Connecticut Department of Transportation

State Project No. 63-703  
Relocation of I-91 NB Interchange 29  
& Widening of I-91 NB & State Route  
5/15 NB Towards I-84 EB  
Hartford & East Hartford, CT

# VALUE ENGINEERING REPORT

June 20, 2016

Figure P4.2: Proposal P4A eliminates the widening of Bridge No. 05796 – Route 15 over Silver Lane and reduces the amount of recently reconstructed Noise Barrier.

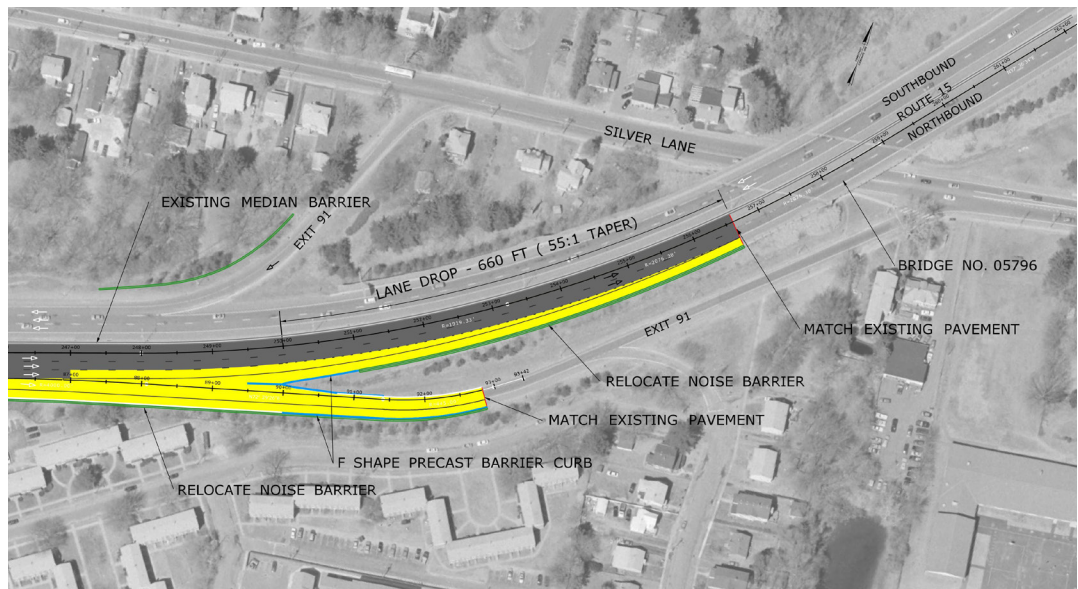
**VE Alternative P4A:** Match the existing two (2) travel lanes on Route 15 west of Silver Lane. A reduction of 550 feet of associated roadway widening of Route 15. This proposal eliminates the widening of Bridge No. 05796 – Route 15 over Silver Lane and reduces the amount of recently reconstructed Noise Barrier.

The cost of this Alternate is estimated to be \$0 or a \$12,811,680 savings from the As Given. The value refers to the cost of the work that would be eliminated should this alternative be chosen.

Figure P5.3: Narrowing of the Shoulder to 4’ on the Connector Roadway.

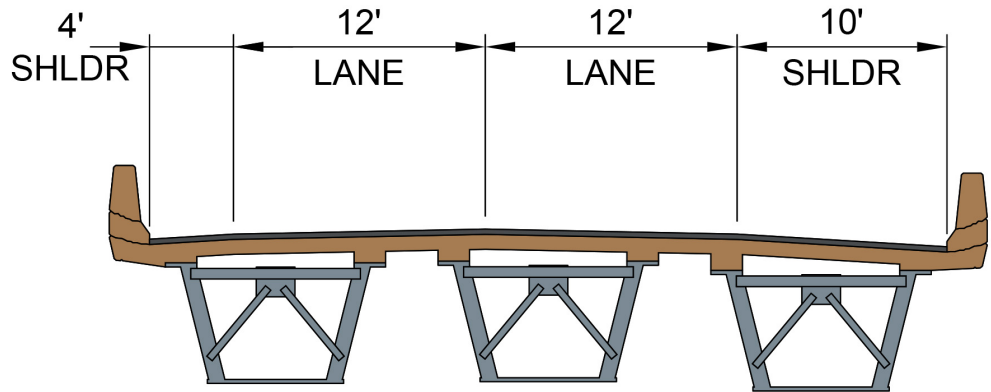
curb-to-curb / 51 feet - 10 inches out-to-out to 38 feet curb-to-curb / 41 feet - 10 inches out-to-out a reduction of 10 feet of width. An additional benefit to be gained by narrowing the connector roadway and bridge for the new Exit 2 Ramp is the potential to alter the alignments of the Route 5/15 mainline and Exit 89 between the I-91 northbound overpass (Bridge 5922) and the Charter Oak Bridge. The potential changes could realign these roadways closer to the existing alignments.

The cost of this Alternate is estimated to be \$30,918,940.

Figure P5.4: New Exit 29 Bridge over Route 5/15 Southbound with a 4-foot Left Shoulder, 11-foot Lanes and a 10-foot Right Shoulder.

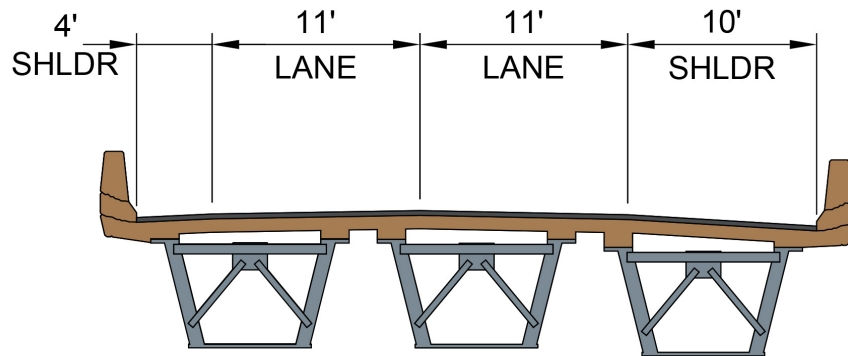
Construct the New Exit 29 Bridge over Route 5/15 Southbound with a 4-foot Left Shoulder, 11-foot Lanes, and a 10-foot Right Shoulder. This is similar to VE Alternative P4A, except instead of 12-foot travel lanes, 11-foot travel lanes will be provided. This 11-foot travel lane width matches the travel lane widths that are being provided upstream on the Charter Oak Bridge. This will reduce the overall width of the bridge from 48 feet curb-to-curb / 51 feet 10 inches out-to-out to 36 feet curb-to-curb / 39 feet 10 inches out-to-out, for a reduction of 12 feet of width.

The cost of this Alternate is estimated to be \$29,431,040.

Figure P7.1: As Given Plan Elevation

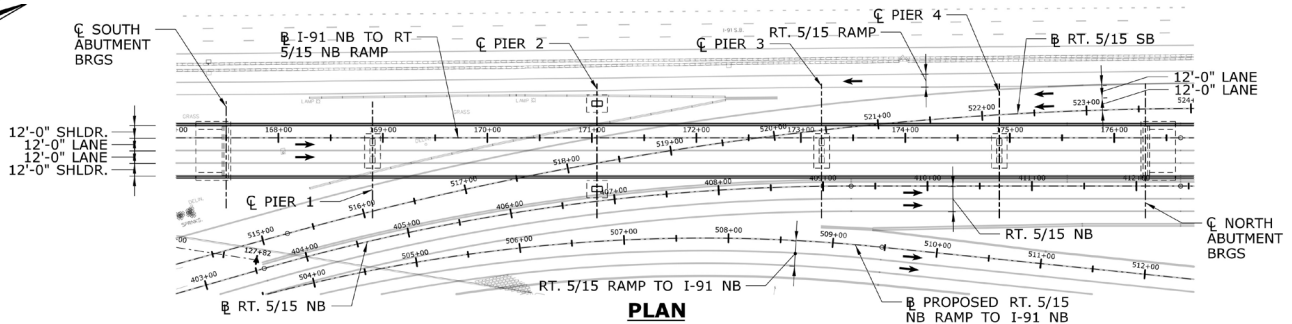
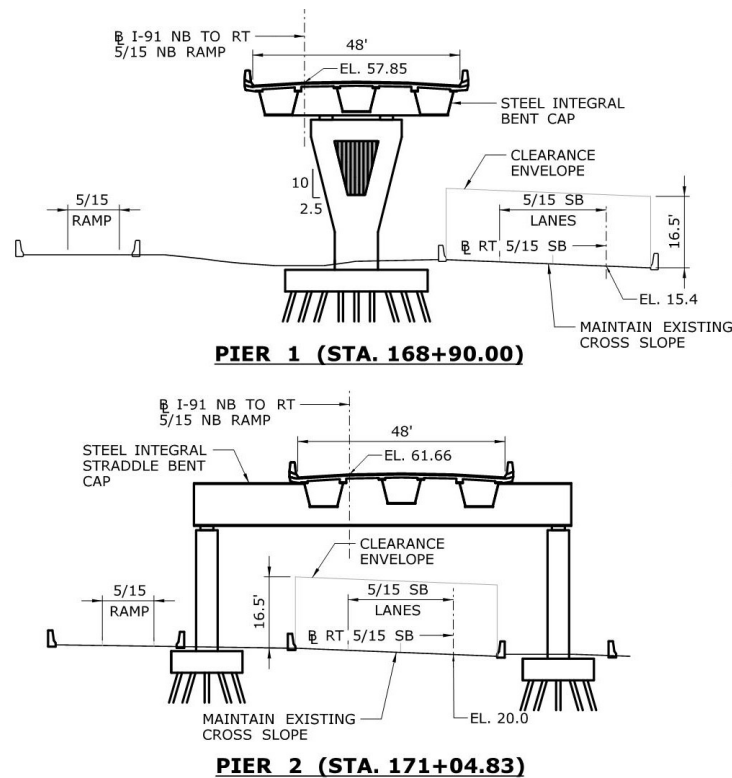
**AS GIVEN:** Construct a five-Span continuous Trapezoidal Box Girder. The spans are 140 feet, 215 feet, 215 feet, 170 feet and 140 feet. The total Bridge length is 880 feet. Piers #1, #3 and #4 are concrete wall piers with steel integral bent caps. Pier #2 is a Straddle Pier. The width is 51 feet - 10 inches. The deck area is 45,610 SF.

Figure P7.3: Three-Span Continuous Plate Girder Bridge

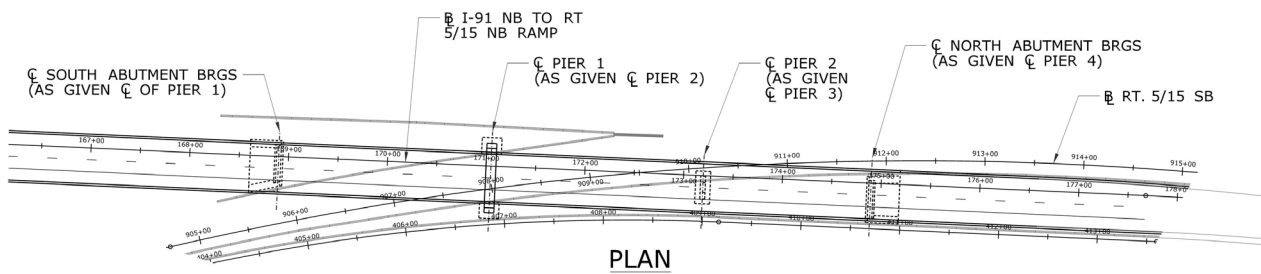
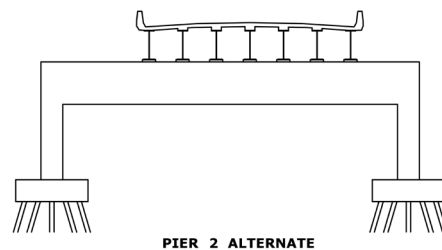
Construct a three-Span continuous Plate Girder. The spans are 215 feet, 215 feet, and 170 feet. The total Bridge length is 600 feet. Pier #1 is a Straddle Pier and Pier #2 will be a Hammerhead Pier. The abutment corners will be clipped to accommodate the barrier below. In addition, the wingwall will be set back to accommodate the barrier below. The width is 51 feet -10 inches. The deck area is 31,098 SF.

The cost of this Alternate is estimated to be \$32,570,000.

Figure P7.6: Four-Span Plate Girder with Approach Span

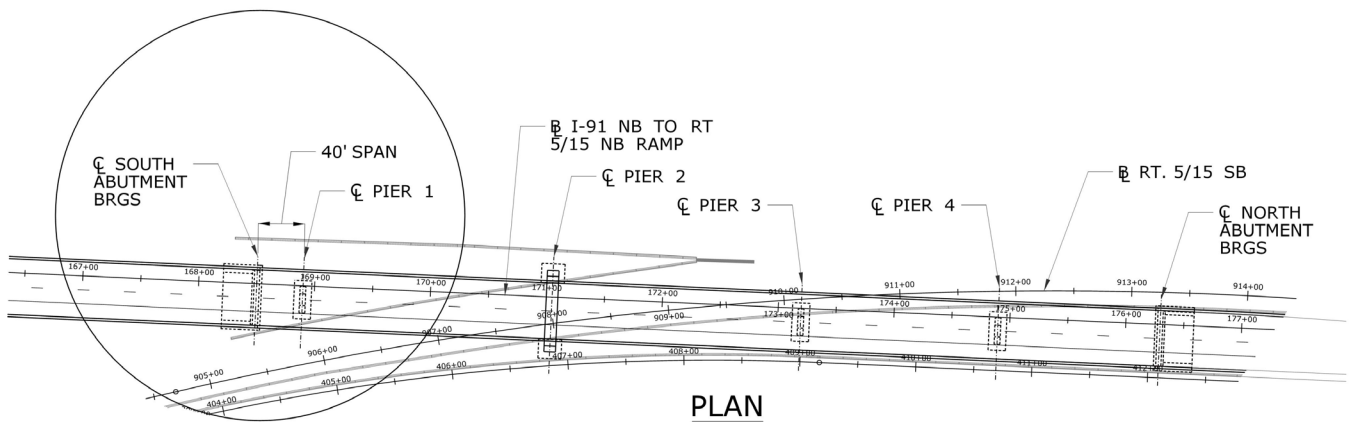
Construct a four-Span Continuous Plate Girder. The spans are 215 feet, 215 feet, 170 feet and 140 feet. Add a 40-foot approach span with precast beams / girders. The total Bridge length is 780 feet, including the single 40-foot approach span. Pier #2 is a Straddle Pier and Piers #1, #3 and #4 will be a Hammerhead Piers. The width is 51 feet - 10 inches. The deck area is 40,428 SF.

The cost of this Alternate is estimated to be \$36,346,000

Figure P7.7: Four-Span Plate Girder

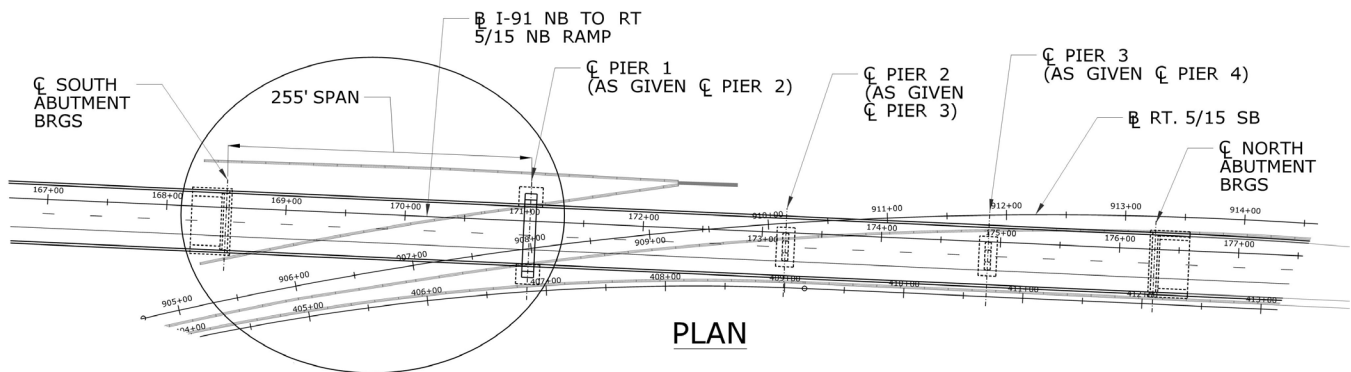
Construct a four-Span continuous Plate Girder. The spans are 255 feet, 215 feet, 170 feet and 140 feet. The total Bridge length is 780 feet. Pier #1 is a Straddle Pier and Piers #2, #3 and #4 will be Hammerhead Piers. The width is 51 feet - 10 inches. The deck area is 40,428 SF. piers. The width is 51'-10". The deck area is 40,428 SF.

The cost of this Alternative is estimated to be \$37,230,000.

Figure DS1.1: Variable Message Signs

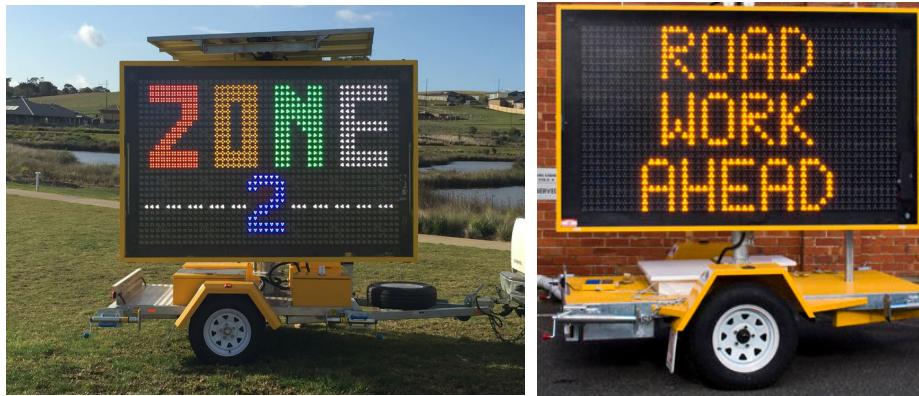
**DS1 –Wide Area Use of Portable Variable Message Signs (VMS):** Provide VMS signing to motorists of construction at all major points for alternate routes south of the construction Area:

- I-91 NB South of I-691
- Route 15 (Wilbur Cross Parkway) South of I-691
- I-91 South of Route 9
- I-91 South of Route 3 – Putnam Bridge

Figure DS5.1: Moment Connection with Mechanical Splicers

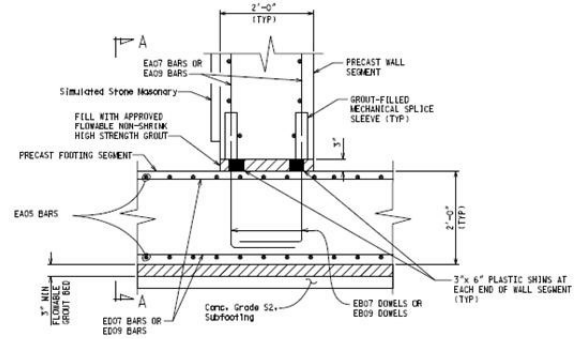
The proposed approach for site retaining walls is to utilize a combination of wall types, including Mechanically Stabilized Earth (MSE) walls, as well as, Cast-In-Place (CIP) wall sections. The VE Team suggests that the Design Team consider the use of precast concrete for the portions of the walls planned to be cast-in-place. Benesch has successfully utilized this concept in prior projects. The precast footings were erected on 3-inch thick cast-in-place sub-footing and the 3-inch gap between the bottom of the footing and the sub-footing was filled with high strength flowable grout. Footings were cast in the plant with protruding dowels and walls are cast with grout filled mechanical splicers. Figure DS5.1 on the following page shows the connection utilized for this work

Benesch utilized this concept for our I-196 project for the Michigan Department of Transportation. The erection rate for precast footing segments was 20 precast footing segments per day (12 foot-long segments) and 20 precast stem segments in the same time frame. The system worked flawlessly even though some of the heavier walls have many alignment changes. This innovative system reduced the construction schedule by four months. The project included 6,762 feet long (160,240 square feet) of retaining walls. The wall height varied from 3 feet - 2 inches to 26 feet - 0 inches. The bid price for this type was about 15% lower than the cast in place concrete wall.
